ADDENDUM #1

Eugene School District 4J South Eugene High School Window Abatement Project 2019

DATE: March 20, 2019

JOB NO: 420.660.033

Window Location Abatement Floor Plan

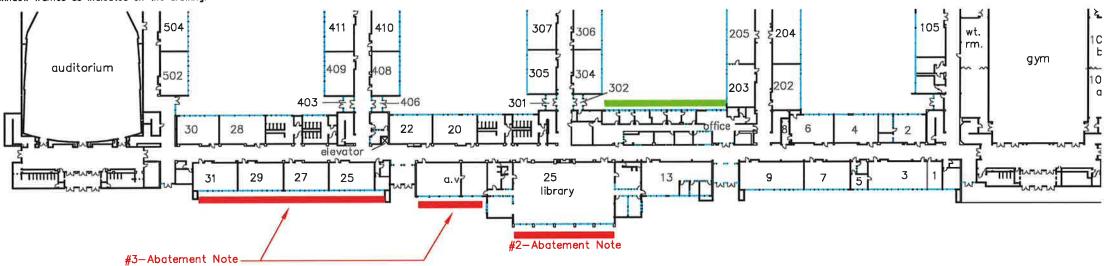
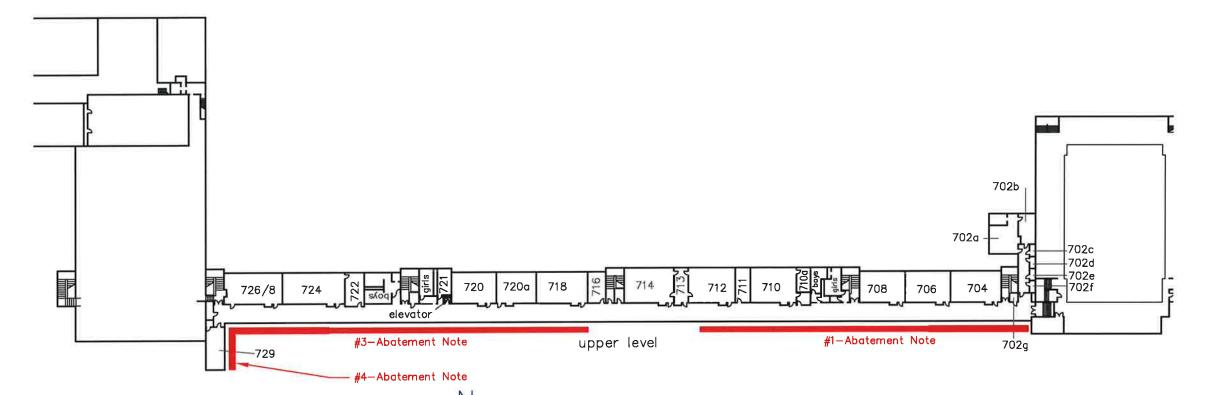
Delete Window Location Abatement Floor Plan that is bound into the Project

Add Window Location Abatement Floor Plan attached to this Addendum

Indicates ADDENDUM #1 Scope of work.
